PCD PROJECT NO. PPR-1950

ARACO CONCRETE
7470 SOUTHMOOR DR., COLORADO SPRINGS, COLORADO 80817

SITE GRADING & EROSION CONTROL PLAN

C1

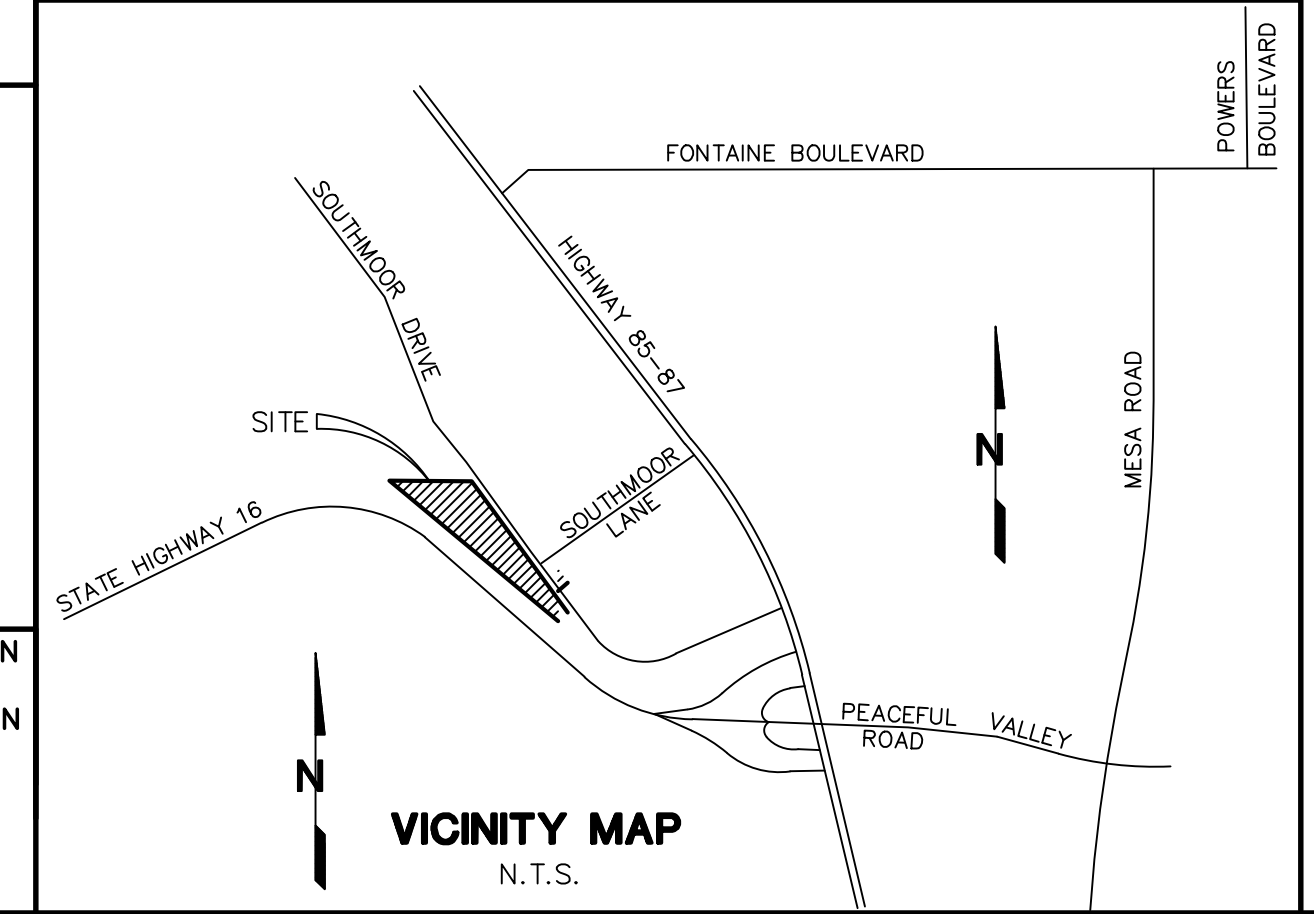
Please revise the concrete driveway and flared sections so that it does not extend into the existing asphalt/roadway. This comment was also provided on the site development plan

Please show the asphalt curb per comment on the site development plan

DETENTION BASIN A1 DETAILS

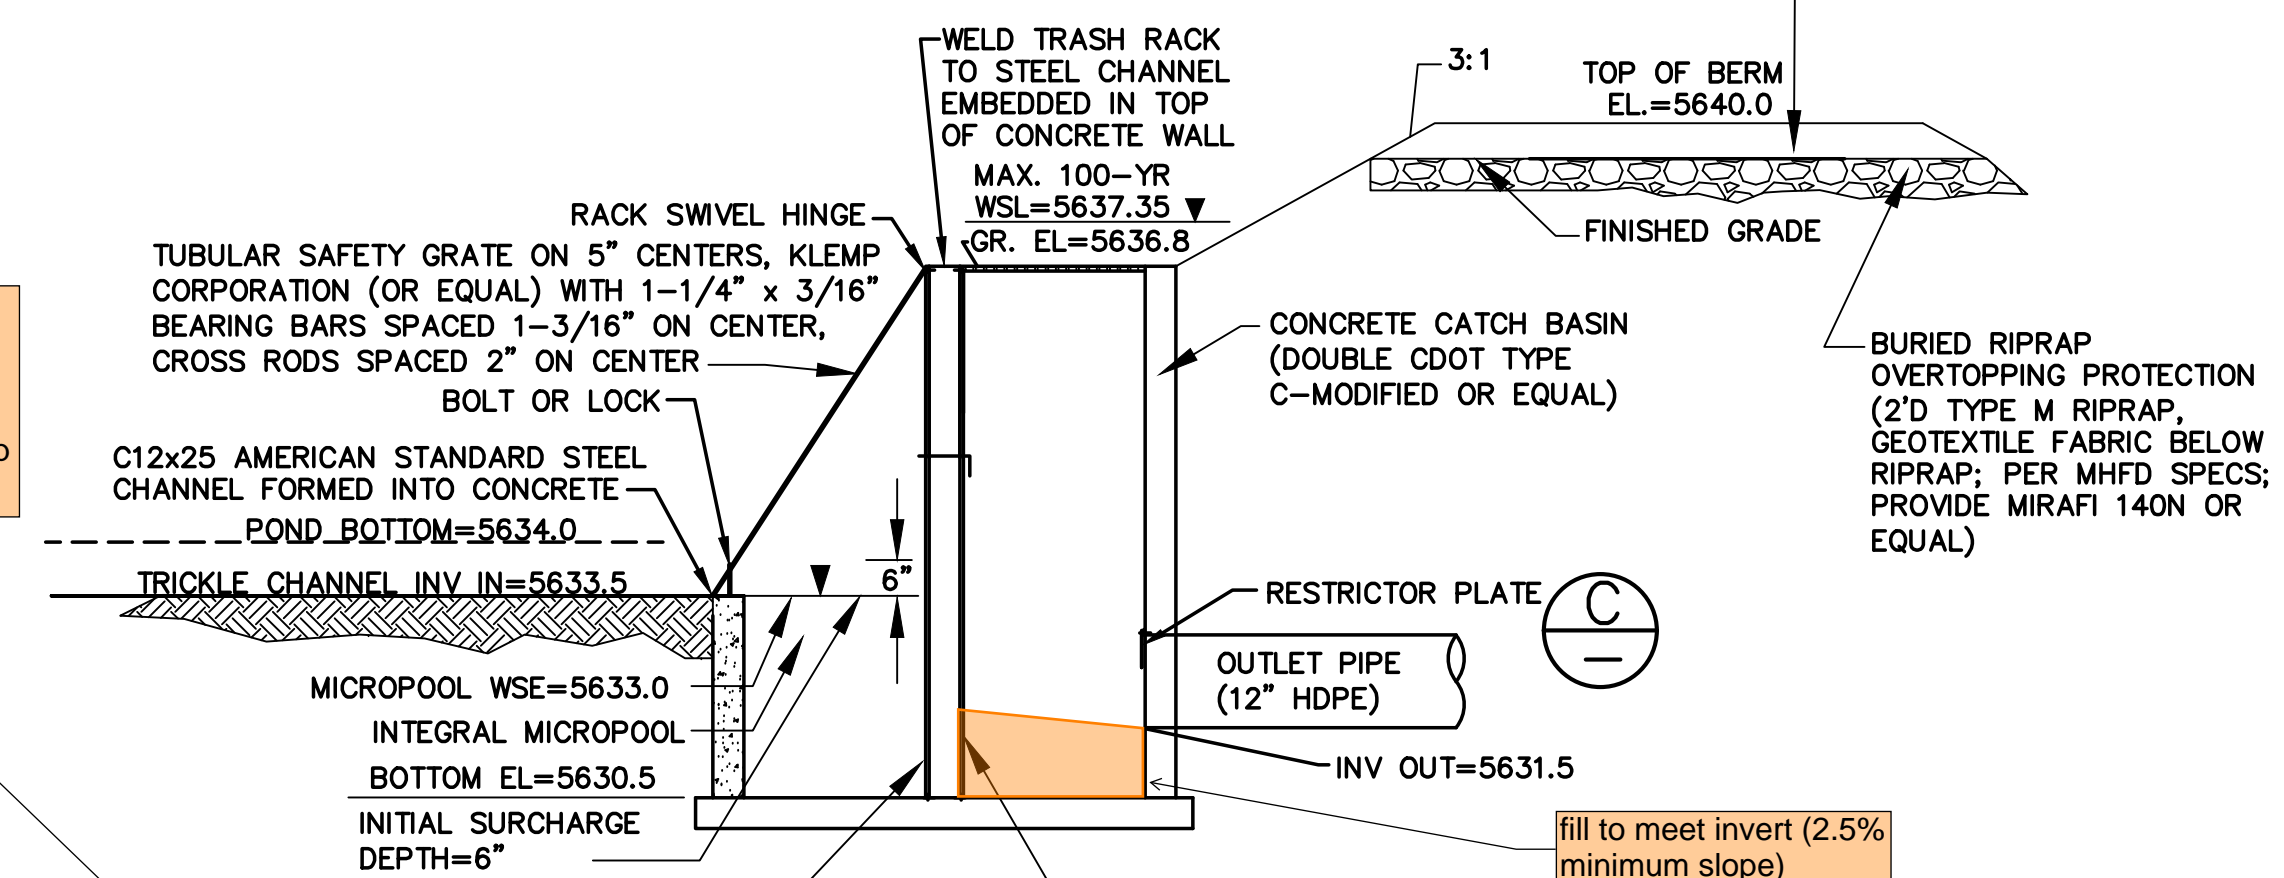
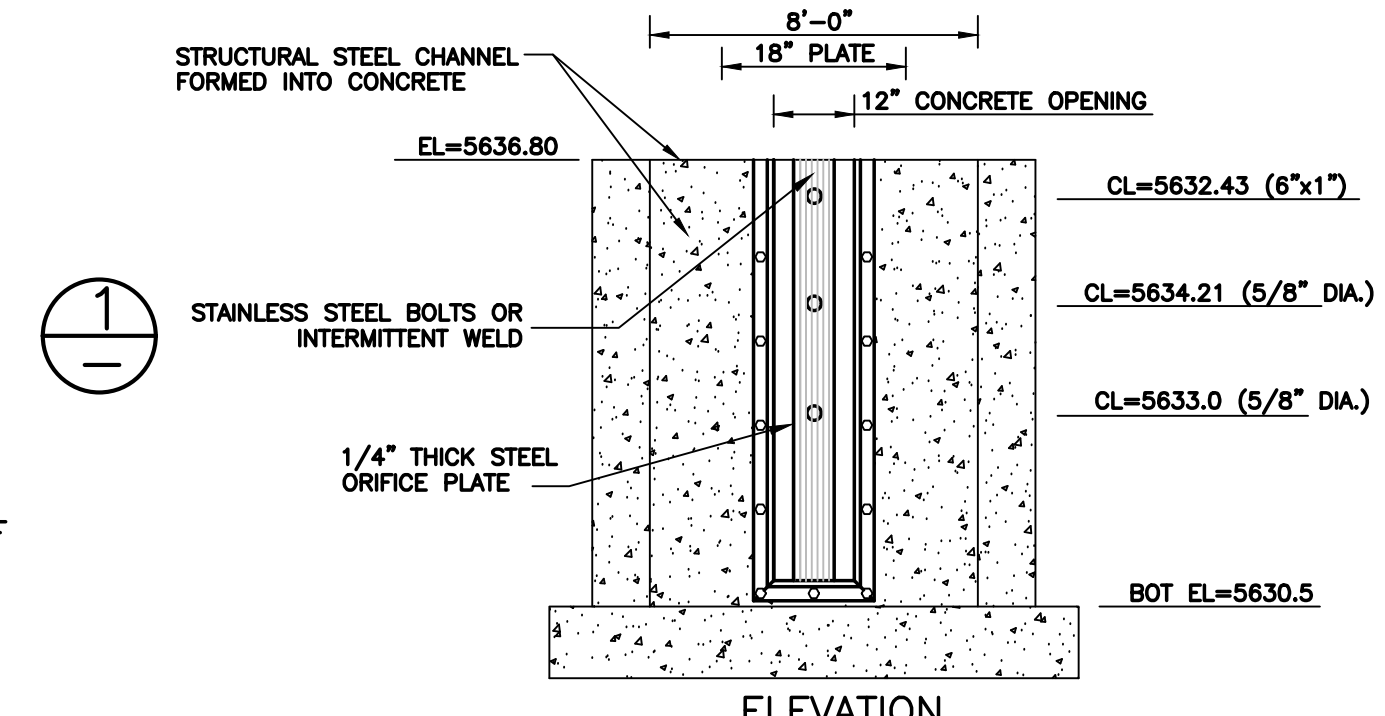
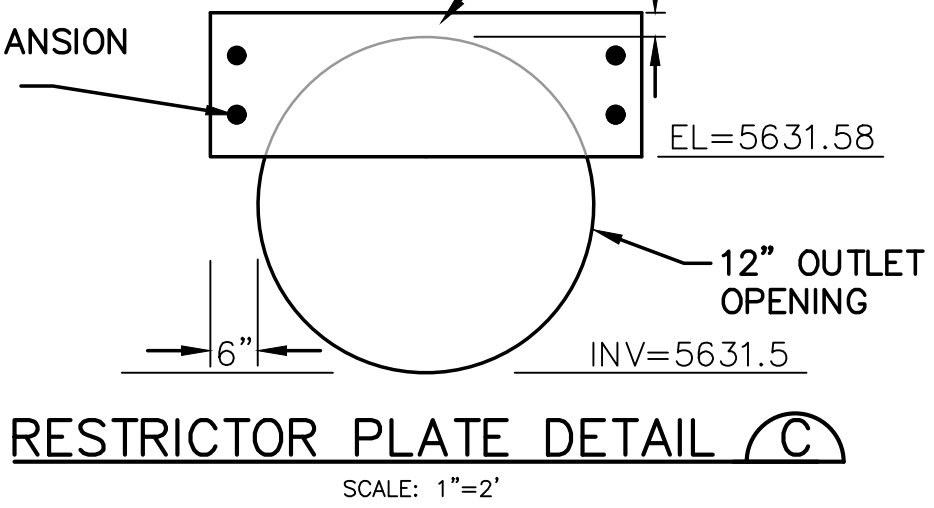
due to the size of the orifice holes (less than 1.25" diameter), recommend using stainless steel well screen with #93 VEE wire, or equivalent (per EPC DCMv2, Chap 4.3 and MHFD Detail T-12)

DETENTION BASIN A2 DETAILS

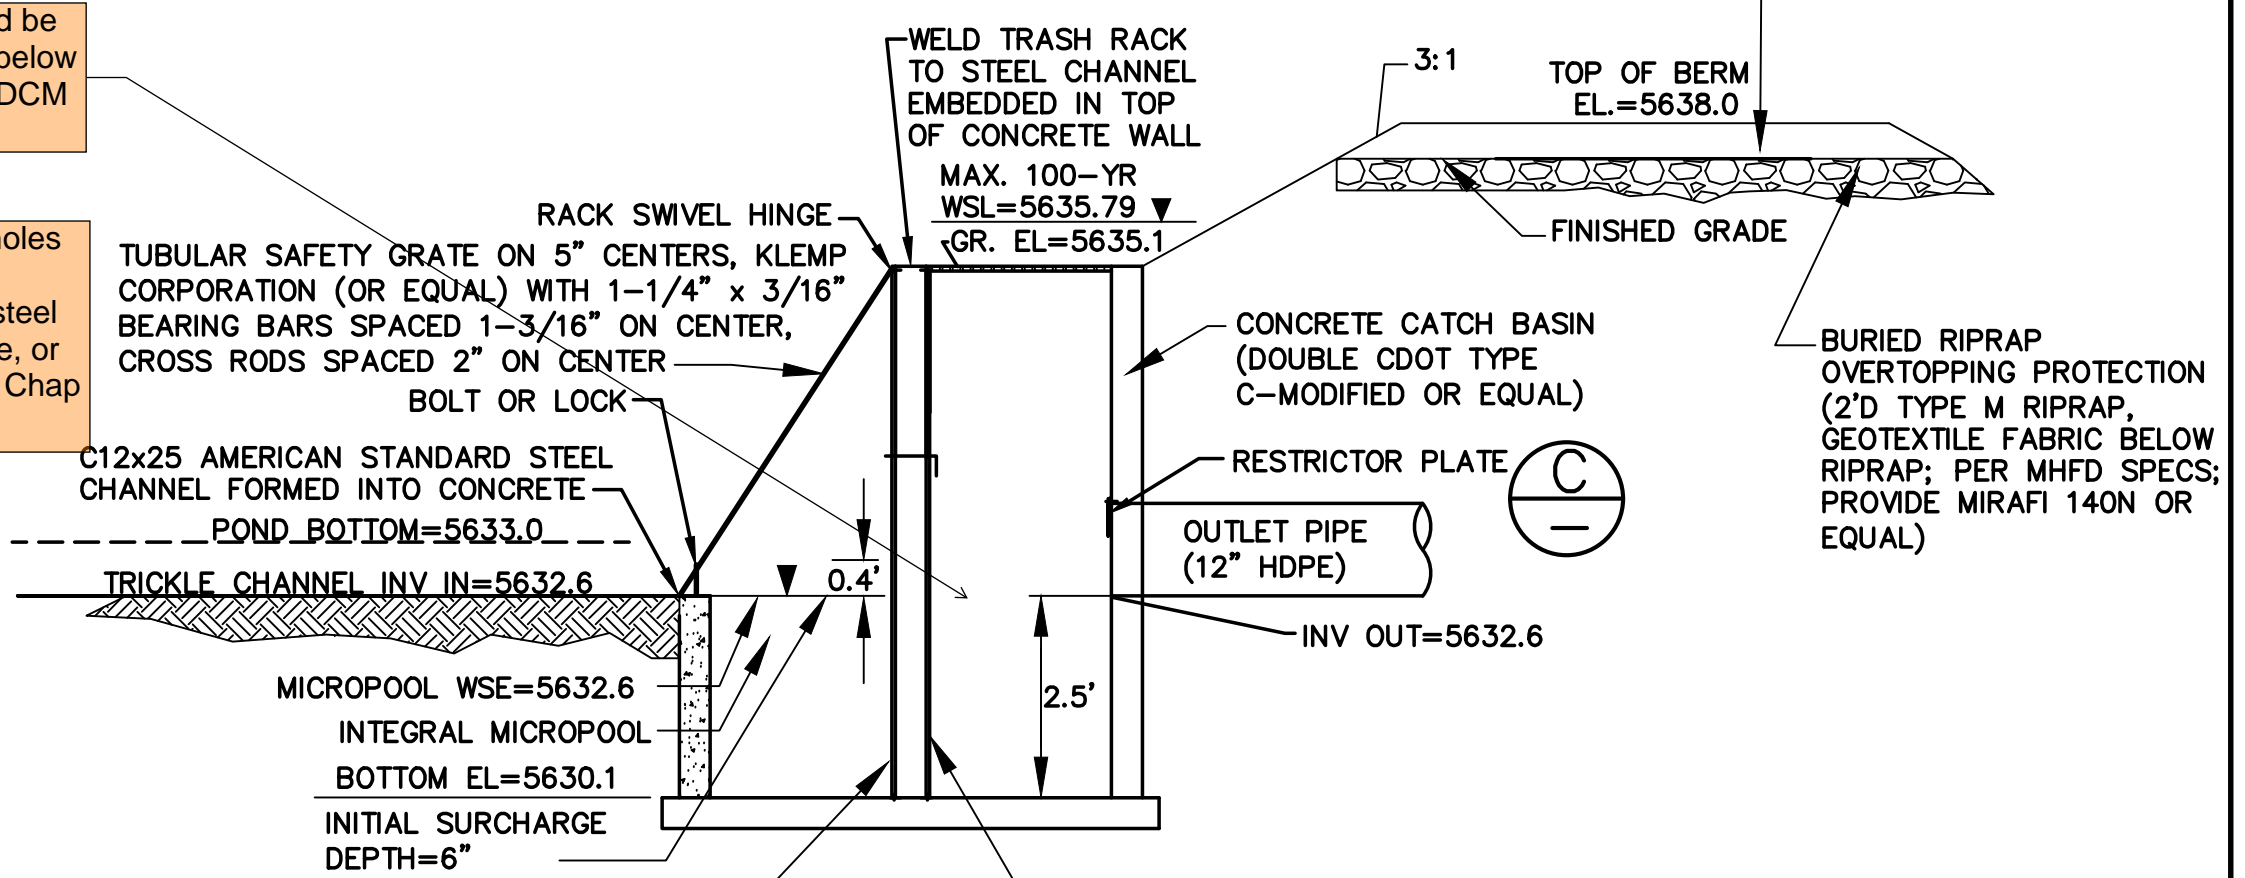
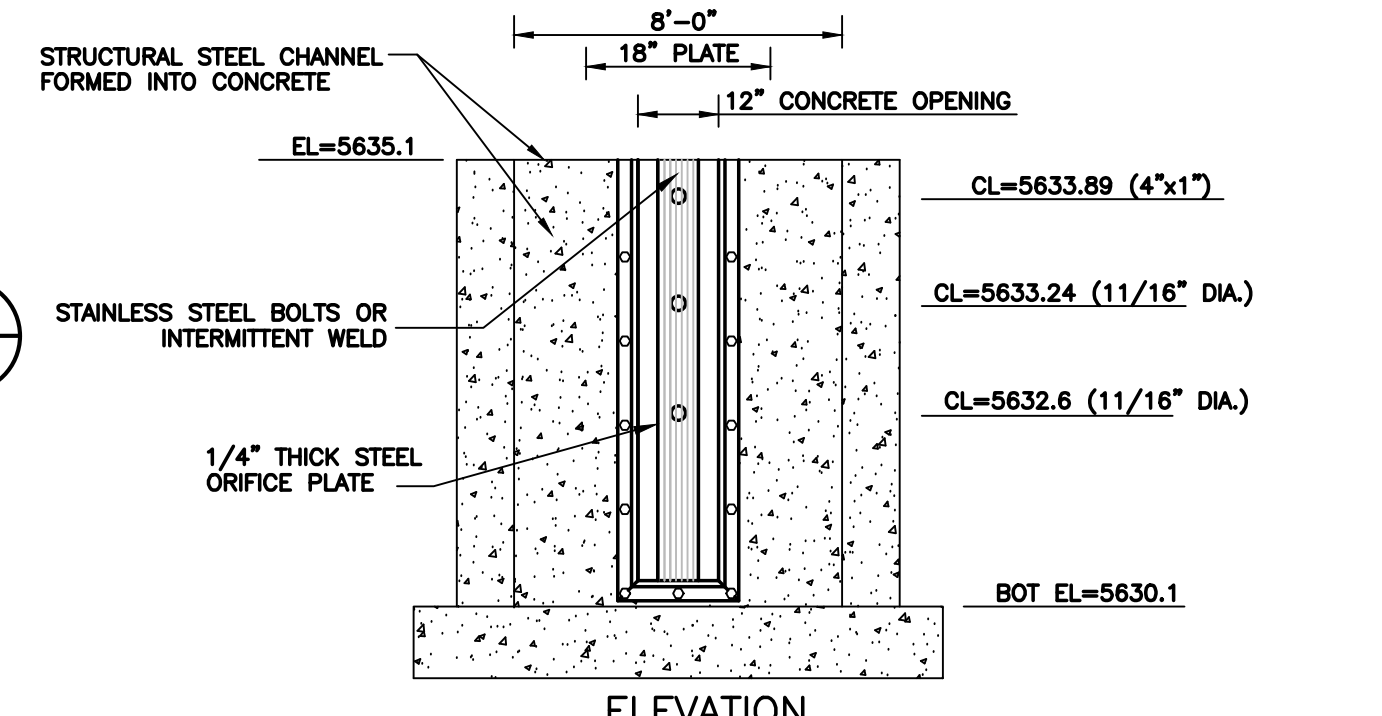
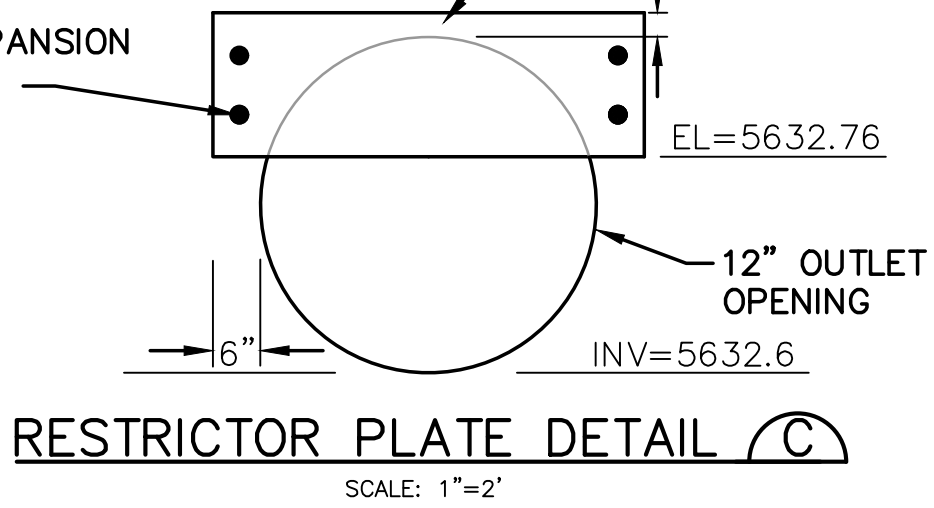
Outlet pipe should be a minimum of 3" below micropool WSE (DCM Vol. 2, Figure 6a)

due to the size of the orifice holes (less than 1.25" diameter), recommend using stainless steel well screen with #93 VEE wire, or equivalent (per EPC DCMv2, Chap 4.3 and MHFD Detail T-12)
